**GOVERNMENT OF THE DISTRICT OF COLUMBIA
DEPARTMENT OF TRANSPORTATION**

MEMORANDUM

SUBJECT: ZC Case No. 14-12 – 1309-1329 5th Street (Edens Angelika)

Figure 1 Site Design and Access (Source: Grove/Slade)

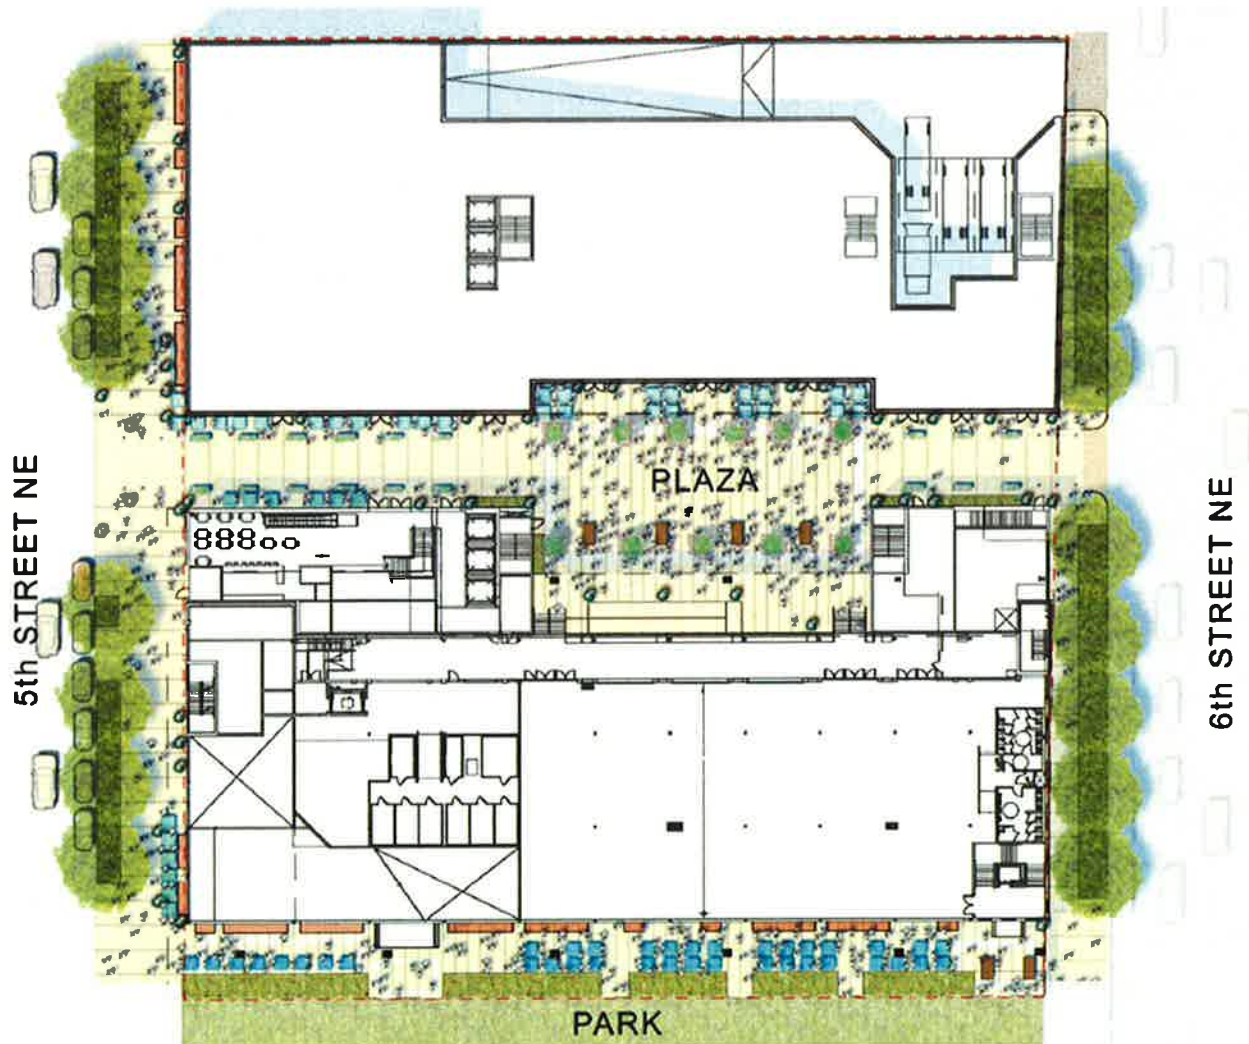
The Applicant proposes to convert 4th Street and 5th Street from one-way couplets to two-way operations as part of the subject PUD and the 1270 4th Street PUD. Conversion of these streets to two-way could improve circulation within the Market and could help encourage the use of non-auto modes by calming vehicle traffic.

A 50' wide easement is recorded along the path of Neal Place in front of the Union Market building, where the Applicant has identified a park and their sidewalk café in the above figure. DDOT has requested the easement document from the Applicant, but has not seen the full agreement. According to the Applicant, the easement requires a "right of way" for "ingress and egress". It is not clear if the easement defines what type of access or mode is required. The easement is evenly split between the subject property and the property to the south. The Applicant's site plan shows the movie theater structure projecting approximately 12.5' into the easement above the existing Union Market building. At ground level, support posts for the Movie Theater and office/residential structure would be located in the easement approximately 12.5' from the Union Market façade. Additionally, the Applicant site plan shows café seating and potential park space within the easement, thus providing limited pedestrian facilities to accommodate east-west pedestrian travel. If the property owner to the south builds to the easement line or constructs projections in the easement area, the navigable area of the easement may become further constrained and the anticipated pedestrian volumes may not be accommodated. DDOT expects the easement to be an important connection for people traveling between the Market and Gallaudet University and Brentwood Hamilton Park to the east. As such, DDOT requests a minimum 10' unobstructed direct path of travel of the Applicant's portion of the easement to ensure future transportation needs and connections are maintained.

The Applicant proposes a non-standard streetscape that features a curb-less street section, wide sidewalks, and new street trees. The Applicant has been working closely with DDOT on the proposed streetscape to determine if the curb-less section can be acceptable to DDOT. While progress has been made on addressing DDOT questions and concerns related to the streetscape, the Applicant's streetscape proposal still has some significant questions regarding the design, including:

- *Easement* – A minimum 10' unobstructed direct path of travel is required of the Applicant's portion of the easement along the south side of the Site to ensure future transportation needs and connections are maintained.
